**A Comparison of Fibre Channel over Ethernet / Converged
Enhanced Ethernet Proposals**

07-336v0

Brocade Engineering Team

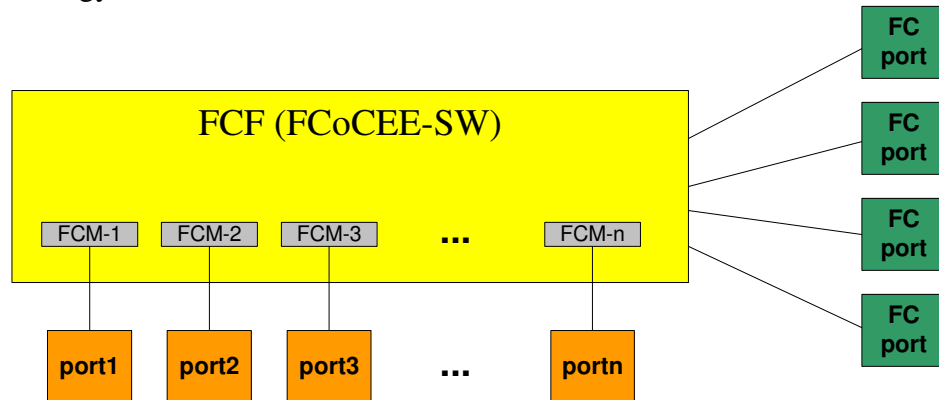
- The Type C model contains a single Ethernet Bridge. FCoE seems to imply that the inclusion of an 802.1Q or 802.1D switch is required.
- The Type D model contains 2 or more Ethernet Bridges. The FCoE proposal seems to discourage the use of this model.

- Is there a need for defining two Types of forwarding models, one for directly connected deployment and another for in-directly connected deployment? Although FCoE provides two different models, FCoE seems to discourage usage of the Type D FCF model.
- Does FCoCEE support both the deployments equally well with a single model. If so, does having a single model simplify user deployment?
- FCoCEE doesn't require an Ethernet Bridge inside the FCoCEE switch. The FCoCEE model appears to support the deployments illustrated in the FCoE proposal without requiring an Ethernet Bridge.

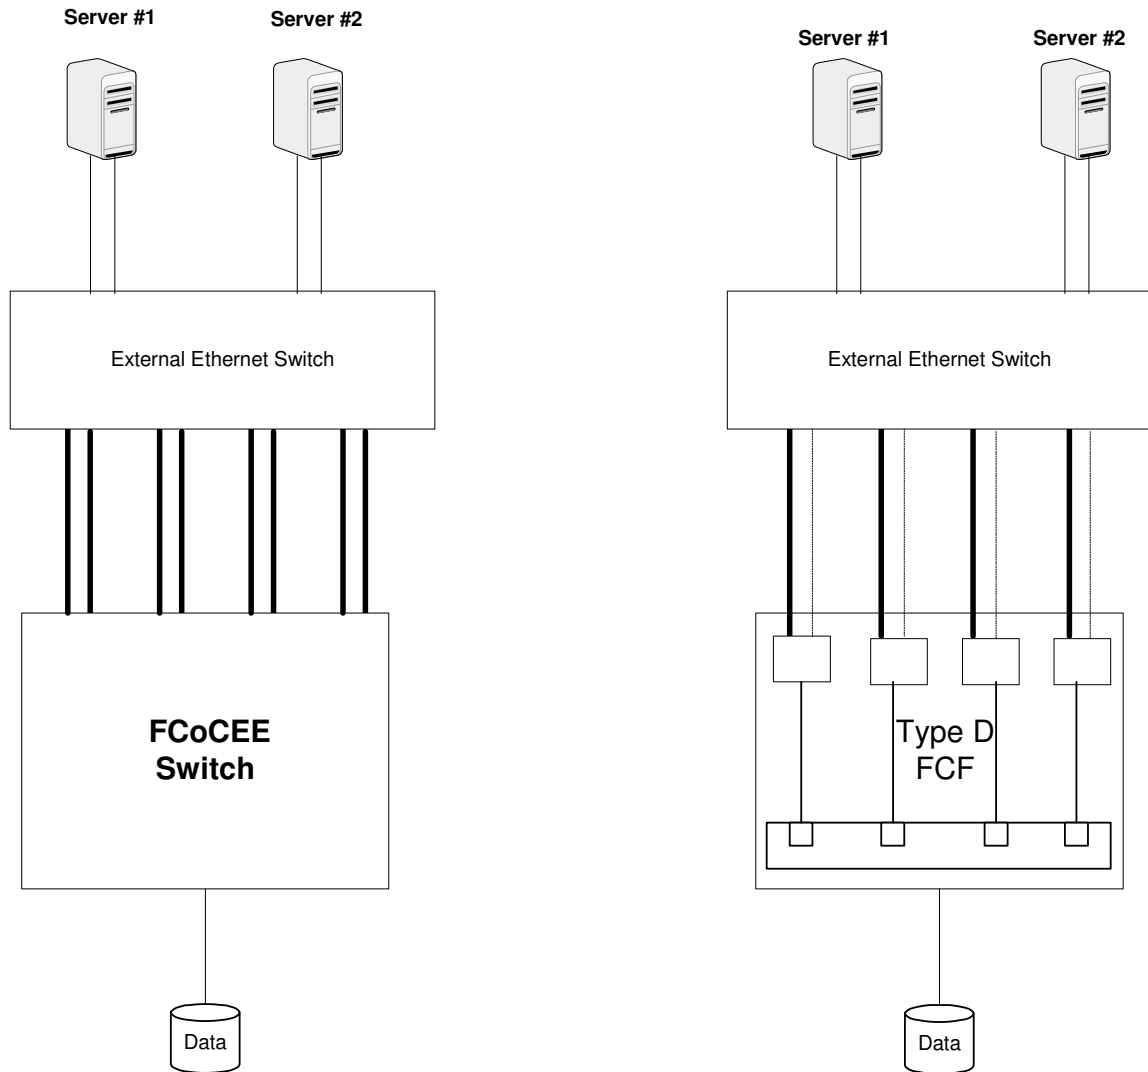
- FCoE requires spanning tree protocol to be enabled on the FCF to eliminate the loops between the internal Ethernet Bridges and the external Ethernet switch. It appears that FCoE restricts each Internal Bridge to be in a single VLAN. It will be assumed that each Ethernet Bridge can only participate in a single VLAN. This effectively makes only one external facing port to be in forwarding state on each internal Bridge. All the other ports are in blocked mode. Ensuring multipathing in this configuration will require extensive VLAN and MSTP configuration as described below:

- One could argue that link aggregation could be used to solve the above problem. It is not clear that this would work. Note that between a given HBA and FCM, all frames use the same source / destination MAC addresses, and there is no IP content. Therefore, there is no indication for the external switch to allow it to identify separable flows to split between the links. Consequently, even if link aggregation is enabled, it is likely that all of the traffic will flow on a single link.

- With FCoE, it is possible that the external switch will flood the FLOGI to multiple FCMs. This problem is exacerbated if one imagines multiple FCoE switches connected to the external switch. FCoE is incomplete in its specification of how this is handled.
